ADDENDUM NUMBER TWO

Indiana University Launch Accelerator for Biosciences 1302 Indiana Ave. Indianapolis, IN 46202

Addendum Dated: OCT 21, 2025

IU Project #: 20250072 BSALS Project #: 00360481

STORMWATER POLLUTION PREVENTION NOTES

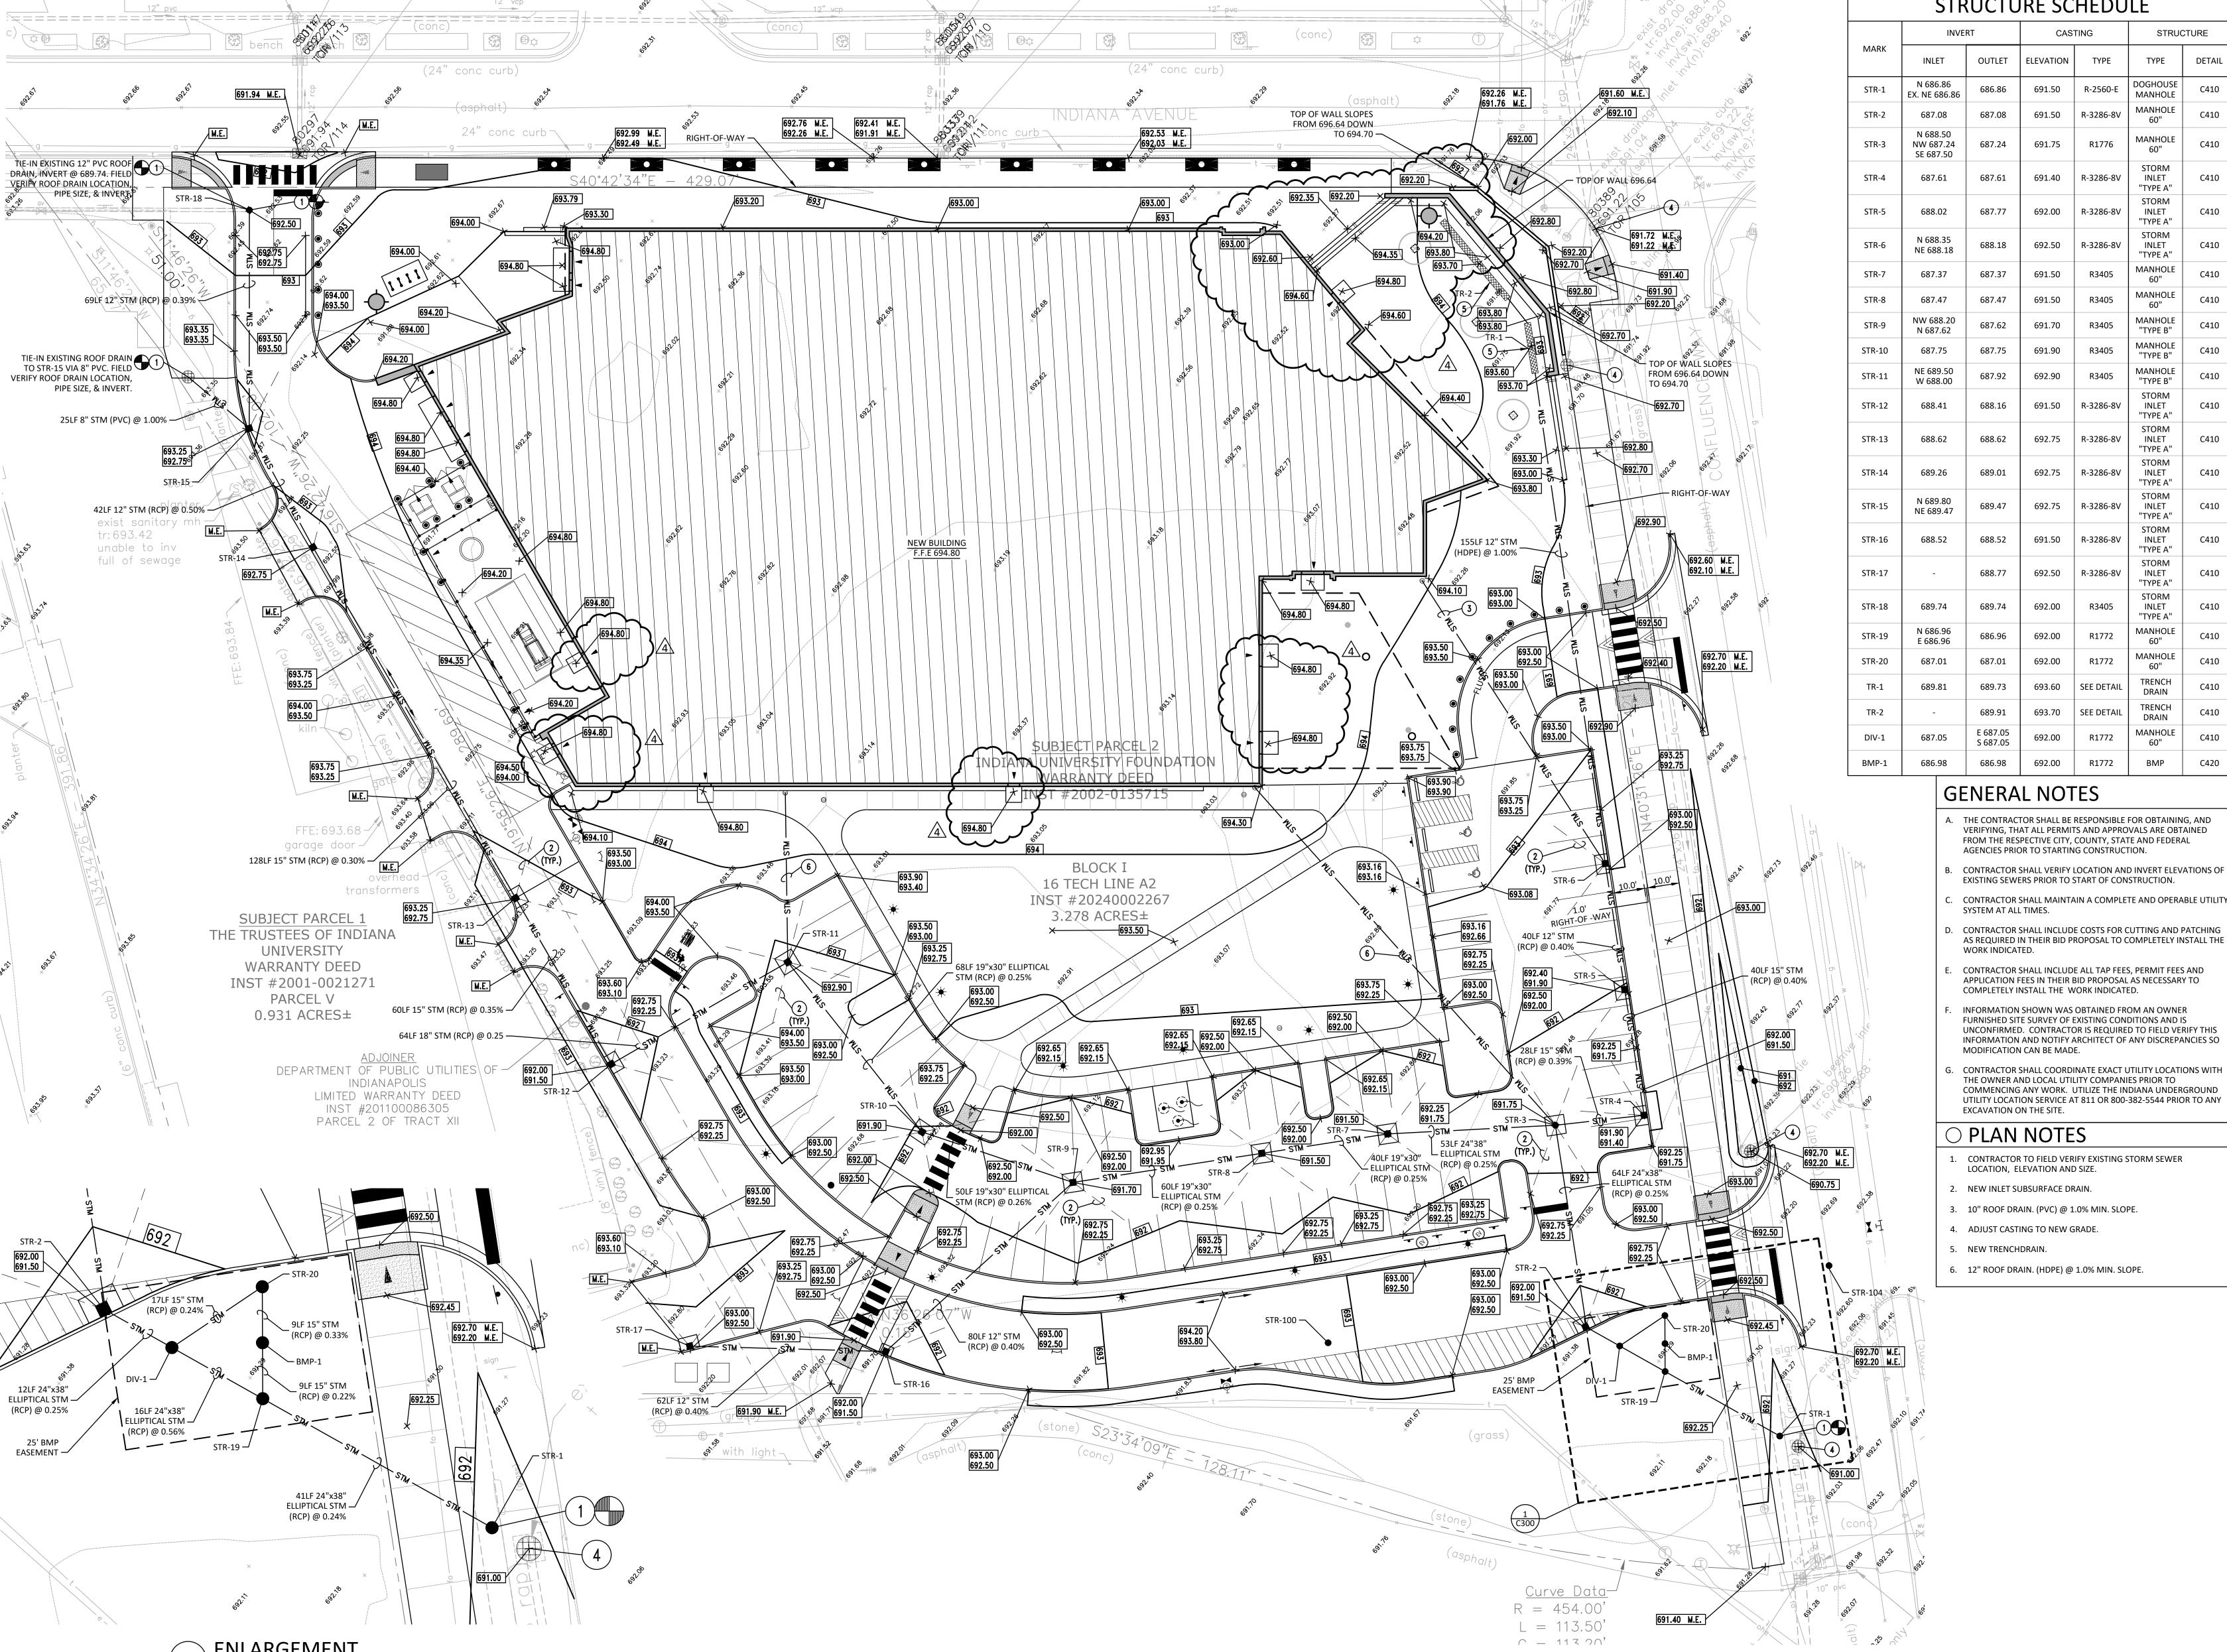
- a. Revise the project narrative under section A3 as shown on the clouded portion of the attached revised drawing.
- b. Revise the references to the BMP to indicate a Storm Settler SSET-6 unit in sections C2 and C3 as shown on the clouded portion of the attached revised drawing.

C300

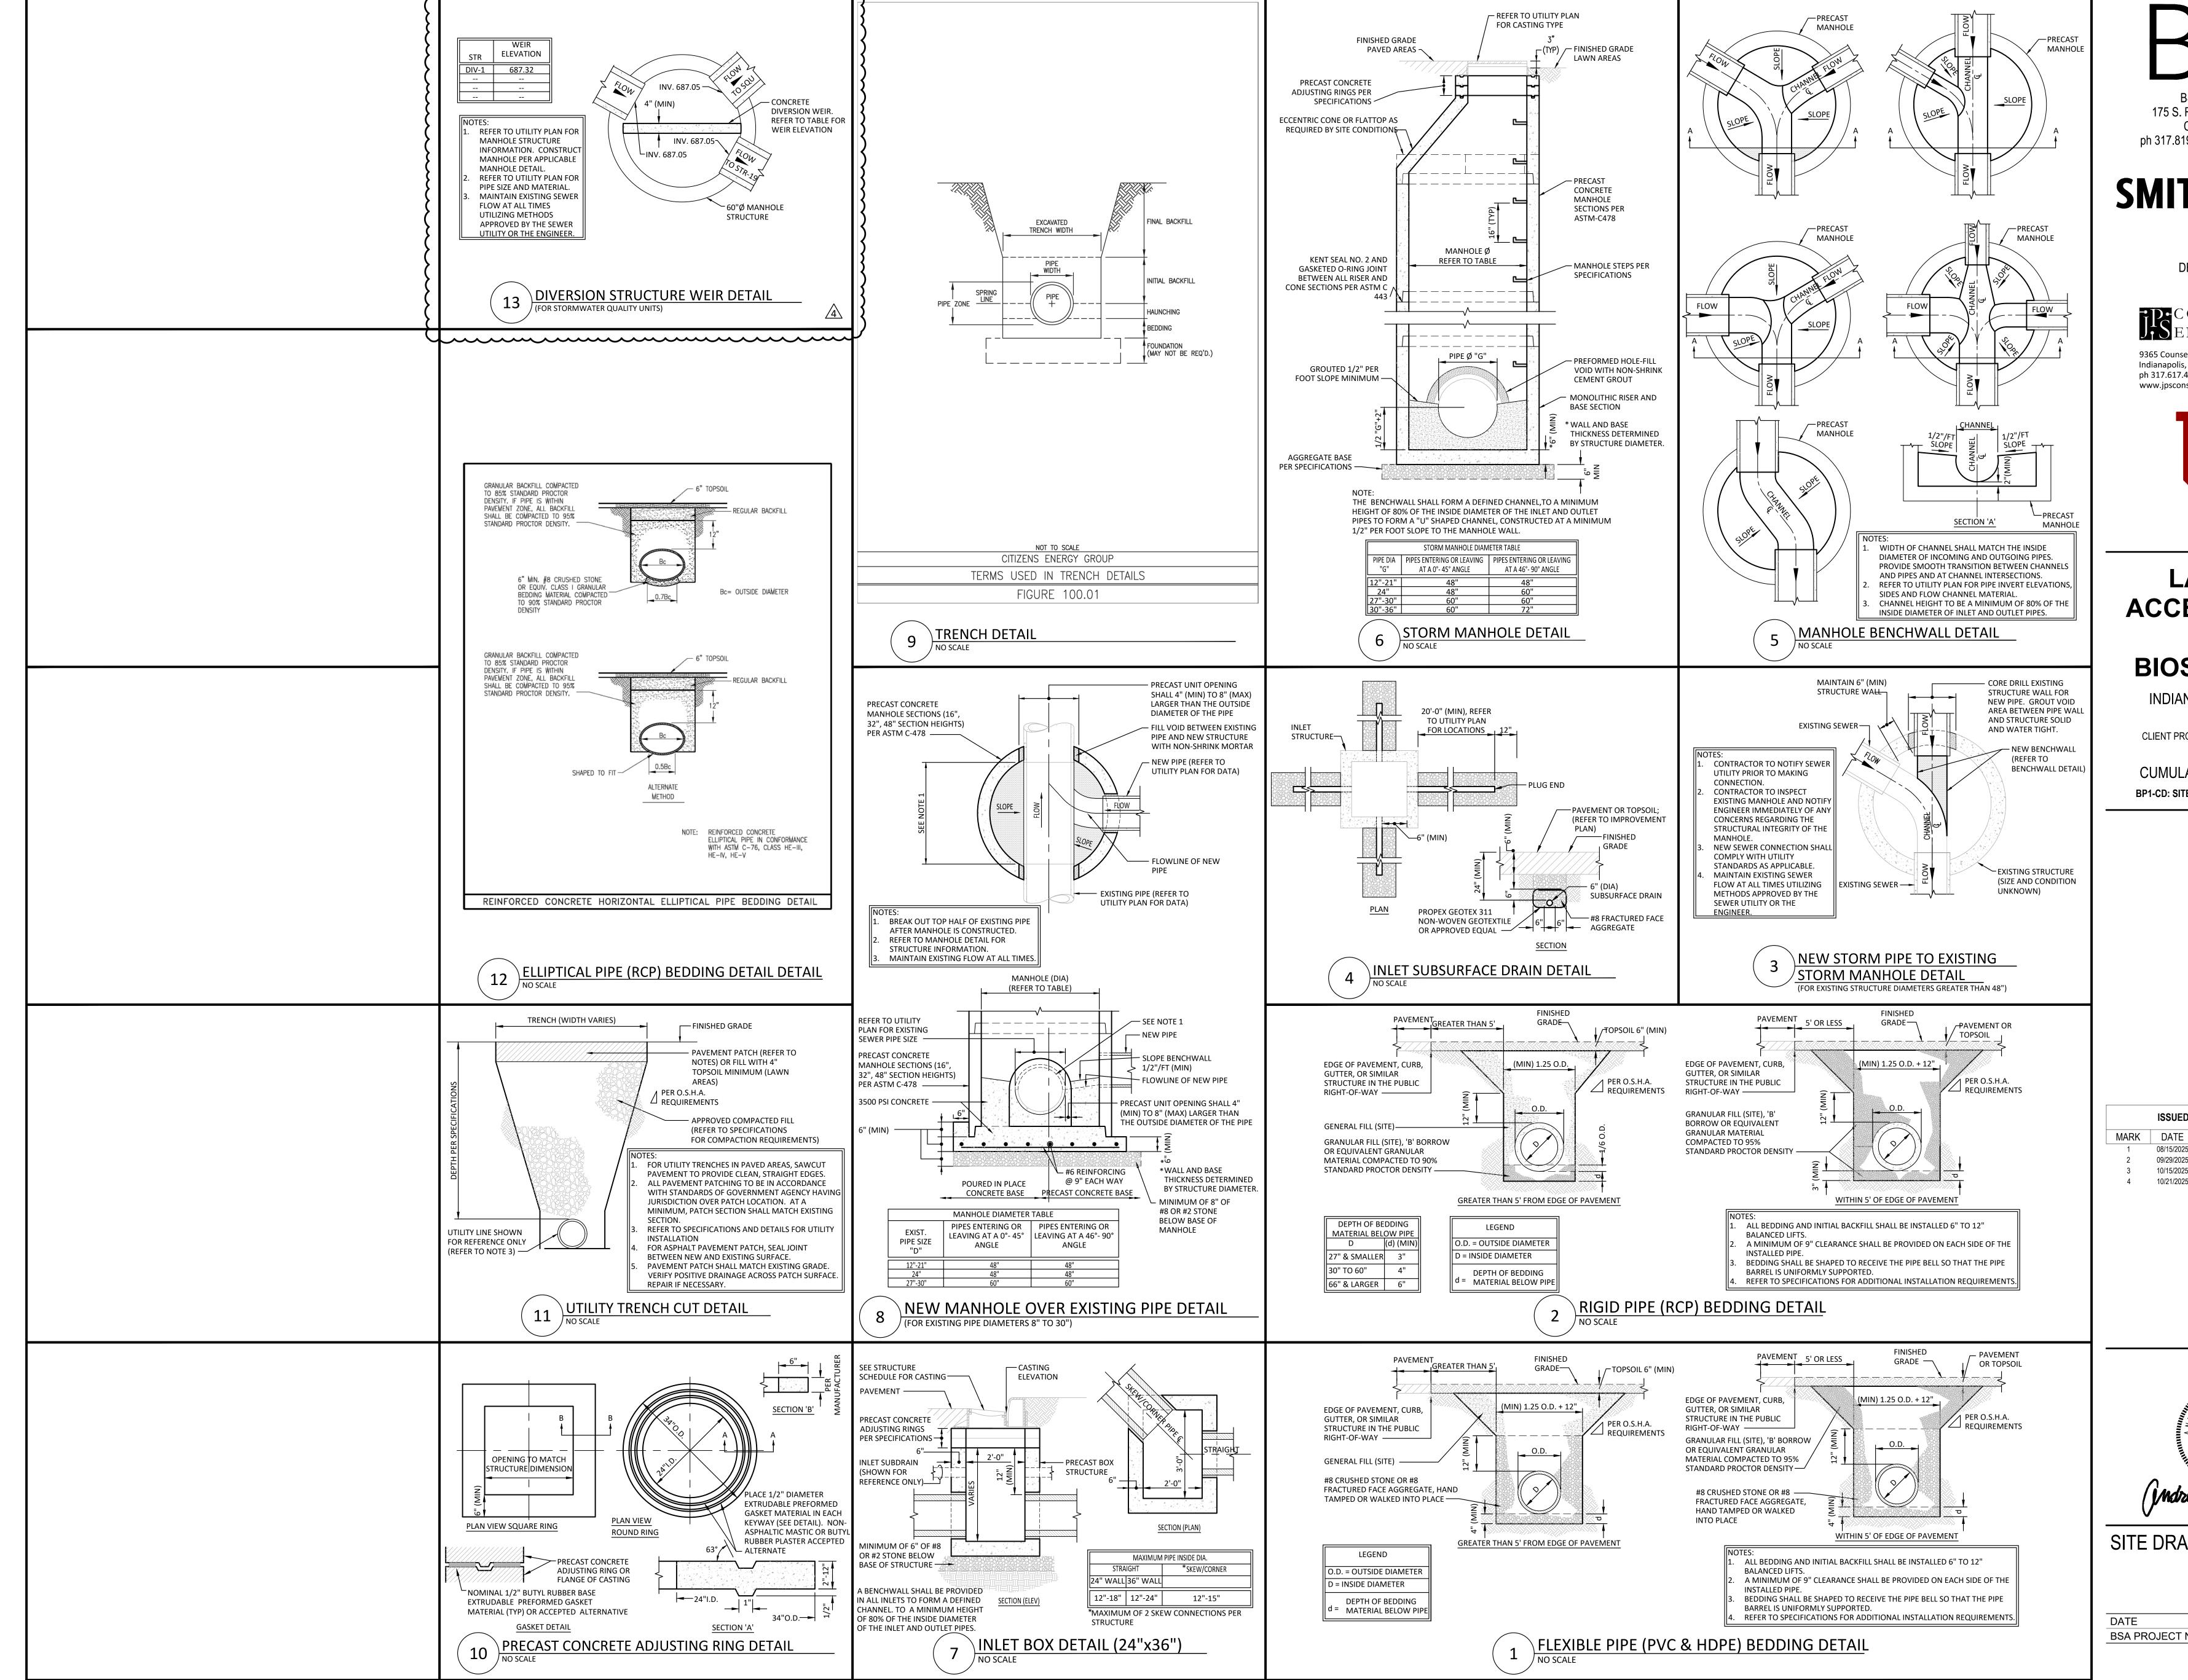
- a. Revise the spot grades in the entry plaza area as shown on the clouded portion of the attached revised drawing.
- b. Revise the stoop locations for the doors as shown on the clouded portion of the attached revised drawing.

C310

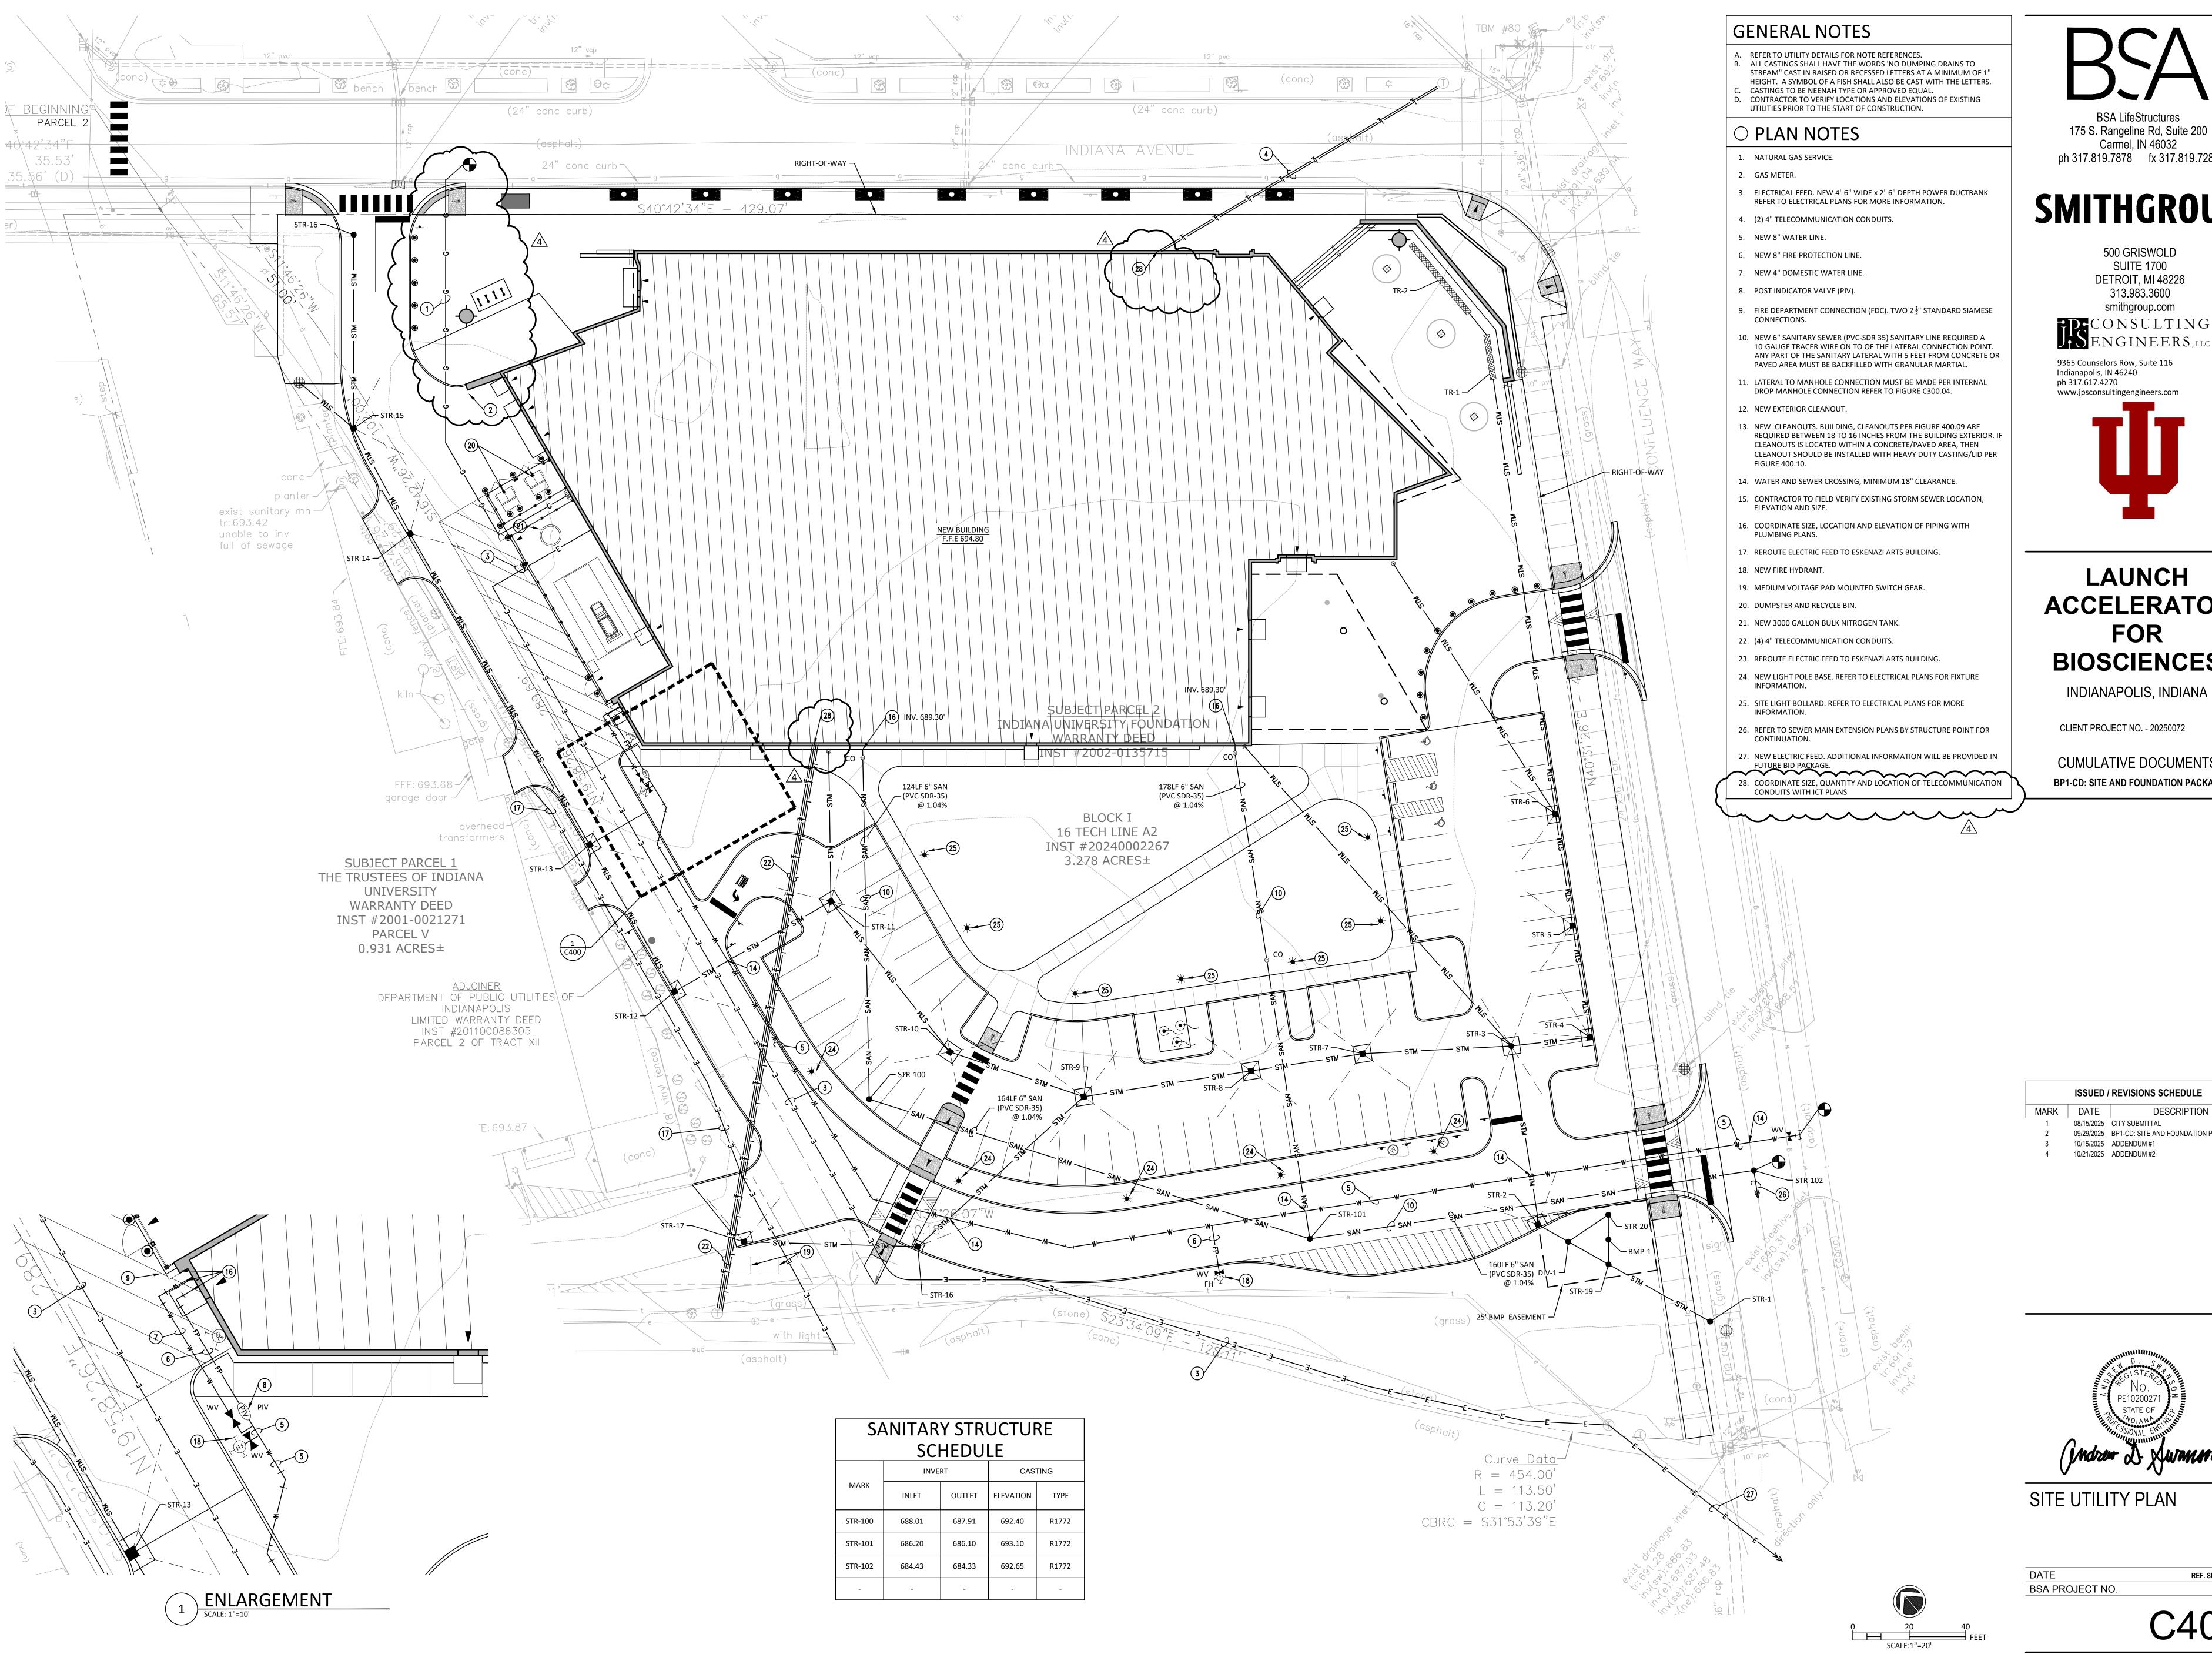
a. Revise the diversion structure detail as shown on the clouded portion of the attached revised drawing.
